IMPORTANT SAFETY RECALL CAMPAIGN ANNOUNCEMENT NHTSA Recall Campaign # 07V-185

RECALL CAMPAIGN

NHTSA #07V-185 / TC #07-130 - 9901074

| Subject: | Incorrect tire load range and pressure on the Federal Certification Label |

Fig. 1

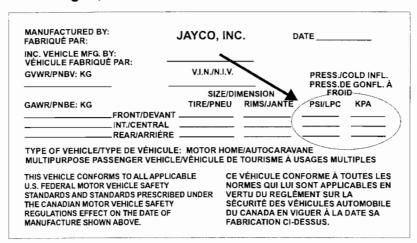
Jayco has become aware that a typographical error was made, incorrectly stating the tire load range and the inflation pressure on the Federal Identification Label. The affected travel trailers were shipped with labels that indicated a tire load range of "E" and inflation pressure of 85psi (586kPA). The correct tire load range is "D" and the inflation pressure is 65psi (449kPA). If the correct tire pressure is not used it may cause premature tire wear and failure.

1. Peel off the incorrect Federal Certification label from the unit and discard it. (Fig. 1)

- 2. Use acetone to remove adhesive residue from the trailer. Apply the acetone with a rag, rubbing in a circular motion.
- 3. Allow the surface to dry for approximately thirty (30) seconds.
- 4. Remove the protective back off the new Federal Certification label, align the labels in the appropriate position and adhere the labels to the trailer. Make sure to remove any air bubbles from the sticker.
